**PCN# 20160629002**  
**Qualification of MAINEFAB for select ABCD150 devices**  
**Change Notification / Sample Request**

**Date:** 7/5/2016

**To:** TOKYO ELECTRON DEVICE (DSTR) PCN

Sample product shipping label (not actual product label)

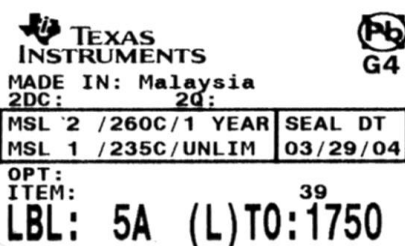
#### Changes to product identification resulting from this PCN:

##### Current

Chip Sites	Chip Site Origin Code (20L)	Chip Site Country Code (21L)	Chip Site City
GFAB6	GF6	GBR	Greenock
GFAB8	GF8	GBR	Greenock

##### New

Chip Site	Chip Site Origin Code (20L)	Chip Site Country Code (21L)	Chip Site City
MAINEFAB	CUA	USA	South Portland
